**SUBMISSION BY  
BETTY BERGER**

Docket Nos. 52-029 and 52-030  
Petitioner Betty Berger's Environmental Report  
September 23, 2010

Subject: Request for comment on the environmental review of the Levy Nuclear Plant Units 1 and 2 combined license application

## Hydrologic Divide

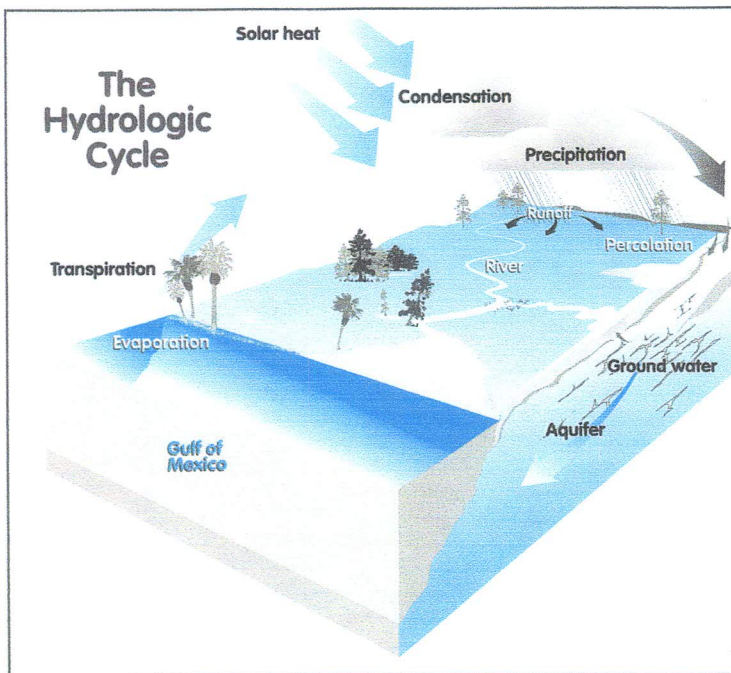
Their site is within the Floridan aquifer which SWFWMD states is fed only by rainfall. There's a Hydrologic Divide that prevents aquifer recharge from either surface or ground water. Four public water supplies south of the site depend on that aquifer, plus thousands of private wells. PEF also plans to consume fresh water of an undetermined amount but near 2 million gals/water/day.

Water laws do not allow industry to affect other users. The threat of saltwater intrusion into our drinking water and the increased usage from the aquifer could affect availability of four public water supplies and many private wells.

2. PEF map 10 mile radius

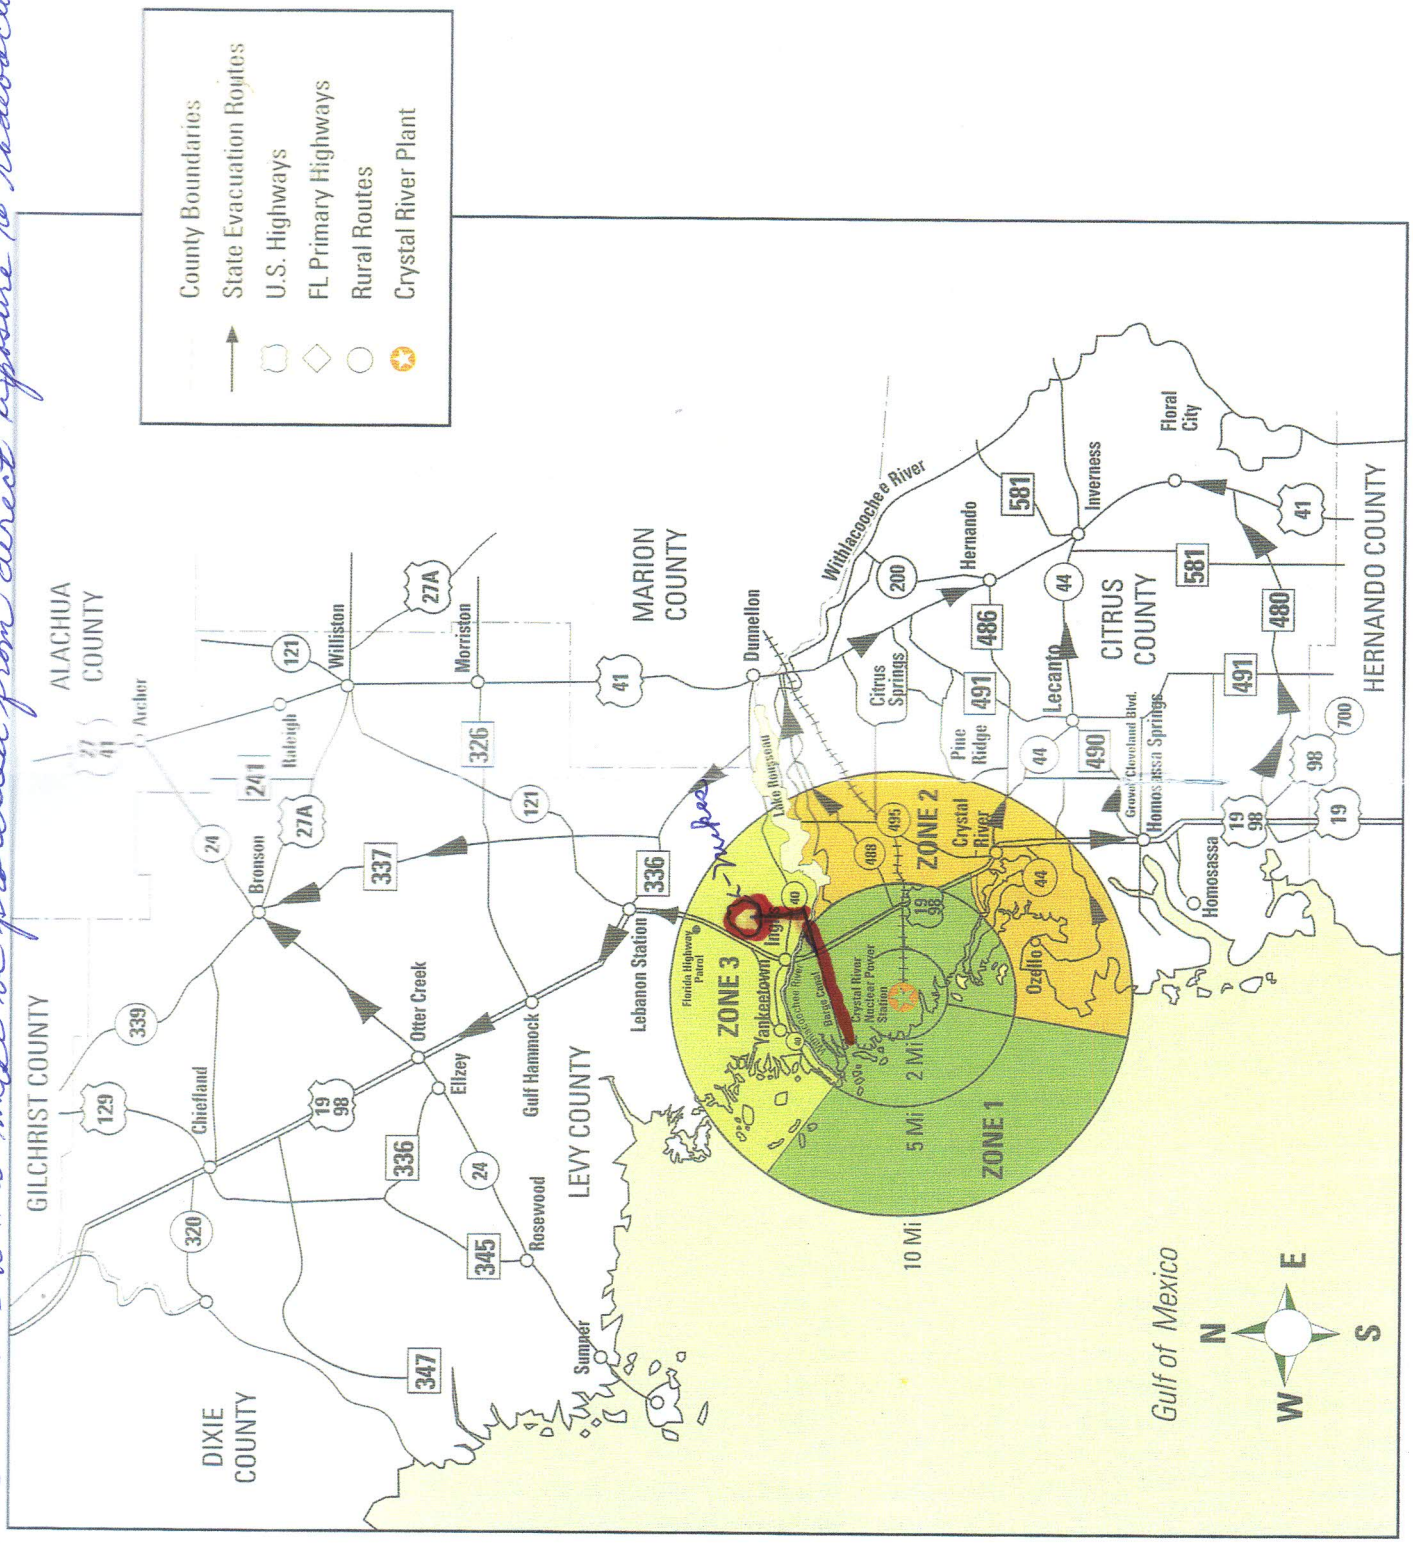
2. PEF has the Crystal River nuclear plant and state "Residents within 10 miles. must be protected from direct radioactive release." They show the area encompassing 10

miles and show the Levy nuclear plants overlapping in the same area. They state the evacuation routes to go south, north and east to escape radiation release. However, Inglis is like the meat in a sandwich. If both sites are affected, there's Crystal River plant in the south, Levy plants in the north, the Gulf on the west and the heavy-haul road preventing escape to the east. The Levy site selected to build nuclear plants could guarantee that no one could escape. If one did, there's the radioactive half-life of several hundred years so there's no return.
